New Albany Planning Commission Meeting Agenda
Monday, August 5, 2024 at 7:00 p.m.

New Albany Planning Commission
July 15, 2024 Meeting Minutes - DRAFT

**MCDONALD'S
FINAL DEVELOPMENT PLAN**

project name	McDonald's - 1955 Beech Road NW
prepared for	City of New Albany
date	June 27, 2024
date received	June 13, 2024

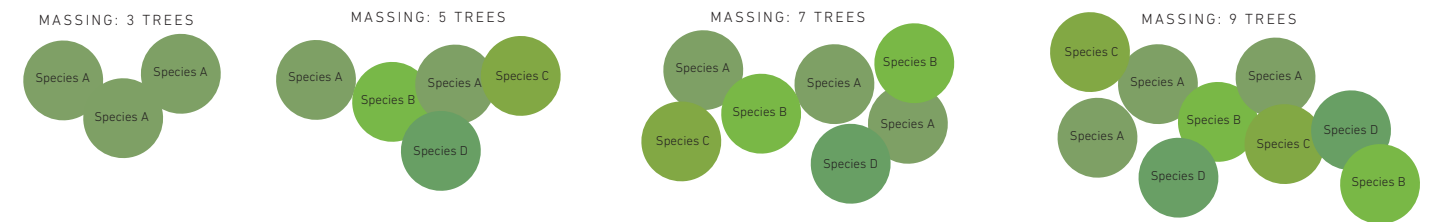
Site Plan

- 1. Further evaluation of the proposed curb cut at the access drive closest to Beech Road NW is necessary to ensure proper function and vehicular circulation. See diagram.
- 2. Reduce asphalt pavement width at drive through. Bypass lane to be 11'-12', reduce from the proposed 18' to 22'. See diagram.

The provided diagram is for clarification and design intent purposes only. The diagram should be used to help illustrate the above comments. It is the responsibility of the design consultants to incorporate the above comments as it relates to the site and to adhere to all City requirements and subsequent code. The diagram may not be to scale.

project name McDonald's - 1955 Beech Road NW
prepared for City of New Albany
date June 27, 2024
date received June 13, 2024

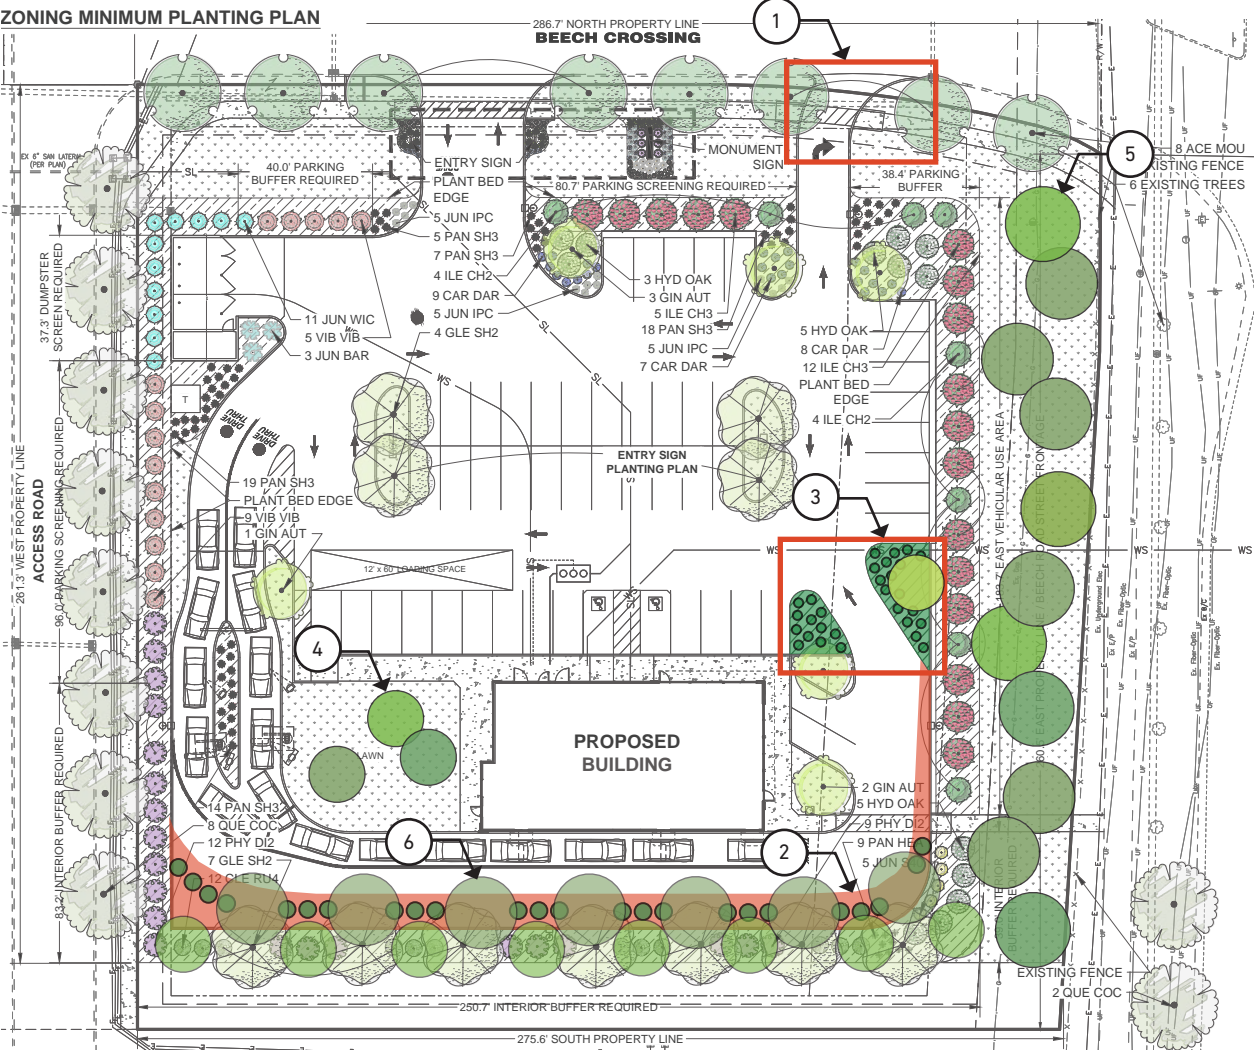
2. Sheet C3.0: Add stop signs/stop bars at the curb cuts.
3. Sheet C3.2: Note that the City requires detectable domes to be red clay brick.
4. Sheet C4.0: Add notes requiring that the water service beneath Beech Road be constructed using Horizontal Directional Drilling. Open cut of pavement is not permitted.

5. Sheet C5.0: Add a legend that includes a major flood routing arrow and show major flood routing in plan view.
6. Sheet C6.1: Revise note 2 at the bottom of this sheet by deleting 21 days and adding back 14 days.

7. Sheet C6.1: The City recently updated the seed application rate to be 14 lbs. per 1000 SF, City of Columbus Type 1 Lawn Mix.
8. Sheet L1.0: Add site distance triangles at the cuts and remove landscaping that impedes motorist view.
